Re: Product change notification for Harwin product.

There has been a change to the tape pocket design on the following products:

Old pocket orientation

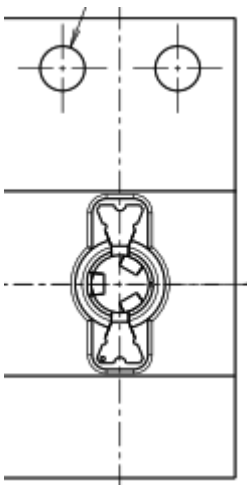
The contacts have changed orientation in the tape:

This revised packaging method has been tested and continues to meet the EIA-481 requirements. The Sycamore Contact sockets are not affected and remain unchanged.

This packaging improvement minimises the risk of these miniature low-profile contacts turning or twisting within the pocket - increasing assembly efficiency.

All new and existing orders at Harwin for S9321-45R and S9341-45R product will be supplied in the new tape and reel packaging. Reels with the new orientation pockets will be clearly labelled for a minimum of 12 months. Using the new orientation will require a change to your Pick/Place machine setup.
